**BOARD OF ZONING ADJUSTMENT
STAFF REPORT****Date: July 11, 2022**

| <u>CASE NUMBER</u> | 6465 |
| <u>LOCATION</u> | 553 Dauphin Street (South side of Dauphin Street, 26'± West of South Cedar Street). |
| <u>VARIANCE REQUEST</u> | SITE: Site Variance to allow a non-compliant gallery frontage in a T-5.1 Sub-district within the Downtown Development District. |

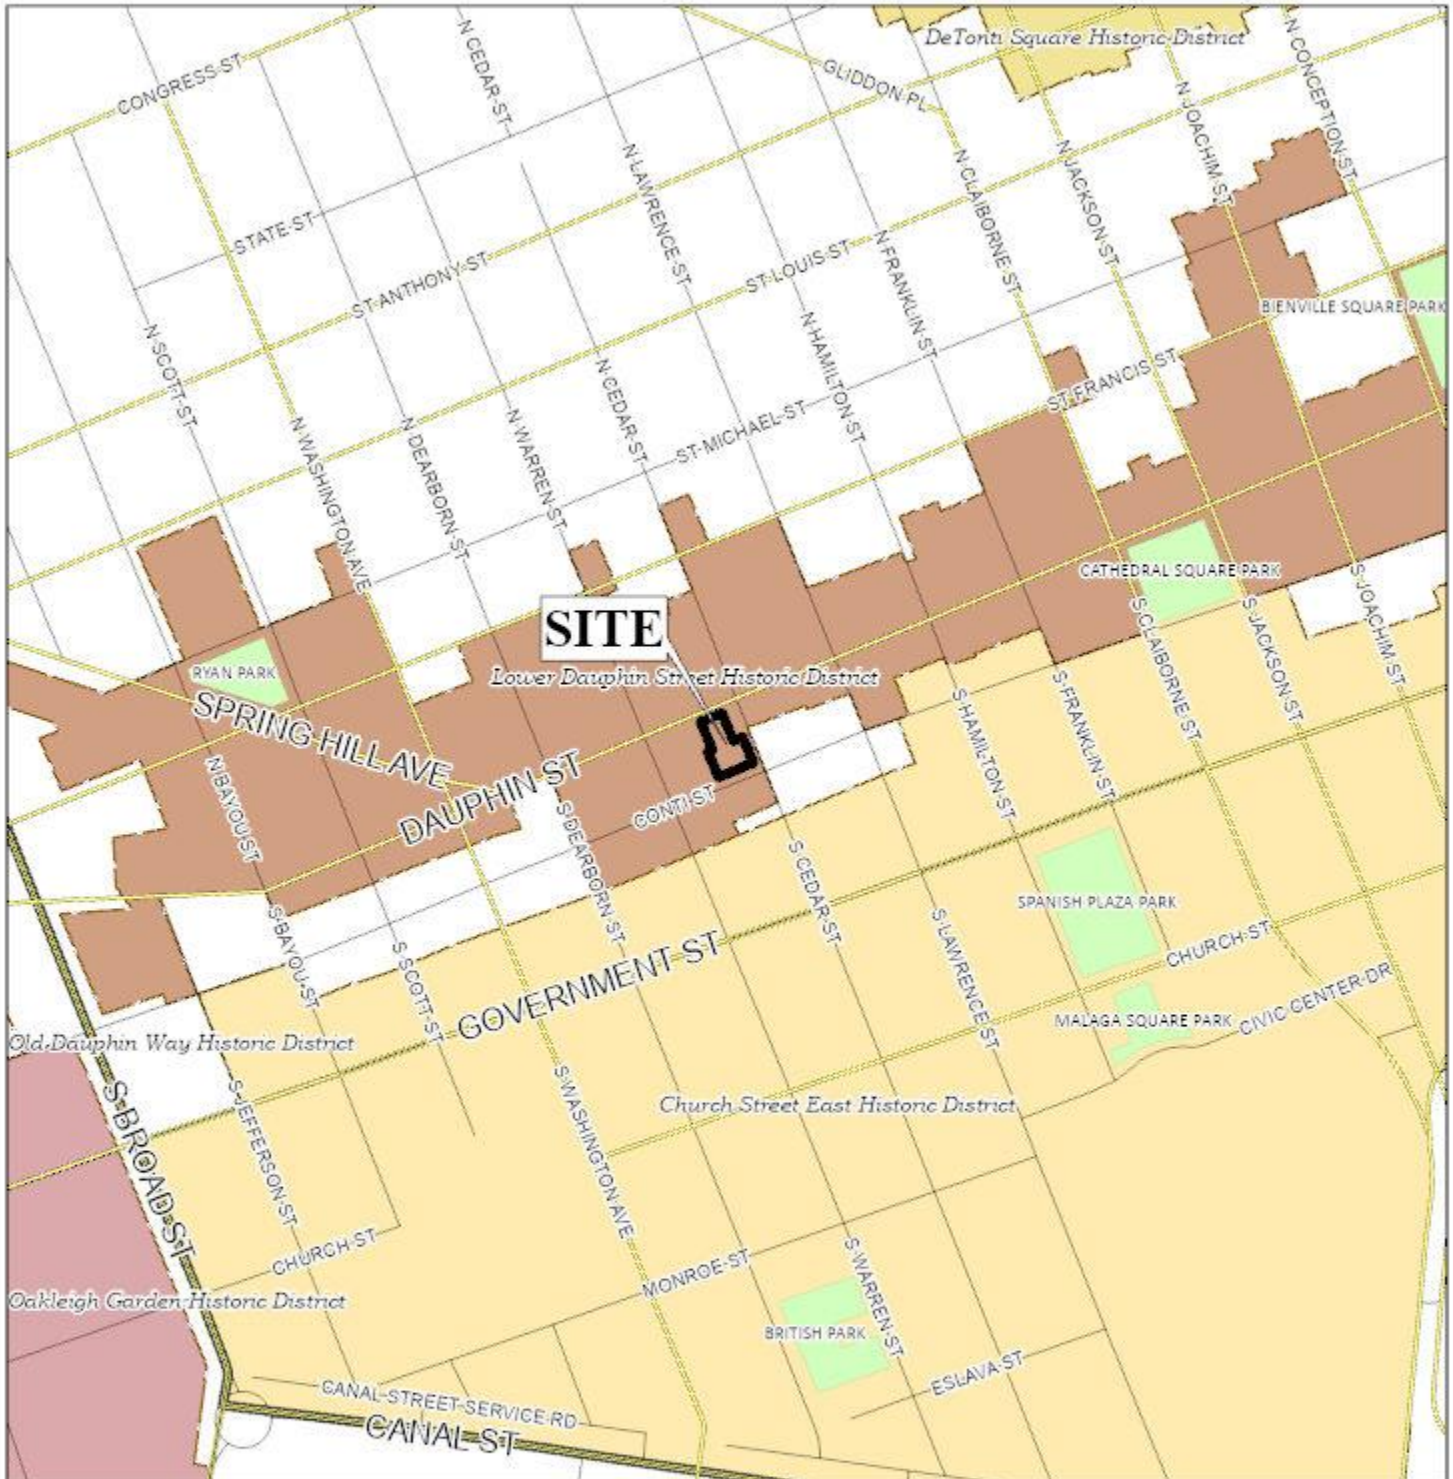
The applicant submitted plans for the proposed gallery addition to the Consolidated Review Committee (CRC) for review, which is where they were advised of the need for a variance due to the proposed gallery having gaps. Section 64-3.I.15.(d)(7)III.iii. of the Zoning Ordinance states "Galleries shall span a minimum of eighty (80) percent of the façade without gaps."

While the subject site may have consisted of two separate structures at one point in time, the structures have been combined since then, and for all intents and purposes, function as a single building. Galleries are a common frontage type in the DDD, which prescribes minimum dimensional standards including the requirements that a gallery have a minimum depth of seven (7) feet from the façade. This seven (7)-foot depth is provided for the two proposed galleries (with the gap); however, due to the existing street lamp, a continuous gallery without gaps, cannot be provided in compliance with the minimum seven (7) foot depth requirement.

- 1) approving the variances will not be contrary to the public interest;
- 2) special conditions appear to exist, that a literal enforcement of the provisions of the chapter will result in an unnecessary hardship in that the existing city infrastructure requires a gap in order to meet other dimensional requirements; and
- 3) the spirit of the chapter shall be observed and substantial justice shall be done to the surrounding neighborhood by granting the variance because it will be in keeping with existing dimensional standards (depth) of balconies within the surrounding area.
